NEC® Correlating Committee
NFPA 70E Second Draft Correlating Committee Meeting (A2026)

December 17, 2025
10:00AM – 12:00PM (ET)
Microsoft Teams Meeting

The attached report shows the number of affirmative, negative, and abstaining votes as well as the explanation of the vote for **each** revision**.**

Figure Informational Note 100.0 Available Fault Current.

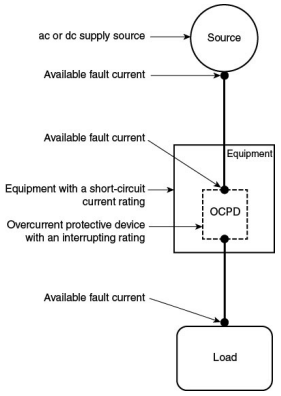
Informational Note No. 1: See ~~Figure~~ Figure Informational Note 100.0 A short circuit can occur during abnormal conditions such as a fault between circuit conductors or a ground fault.

Committee Statement: The title and references to Informational Note Figure 100.0 are updated for clarity and to remove redundant language.

Response Message: SR-2-NFPA 70E-2025While the fault current also varies, the figure depicts that the available fault current varies at different locations in the system as indicated in Informational Note No. 3 to the definition of “available fault current”. The figure is not associated with the defined term “fault current”.
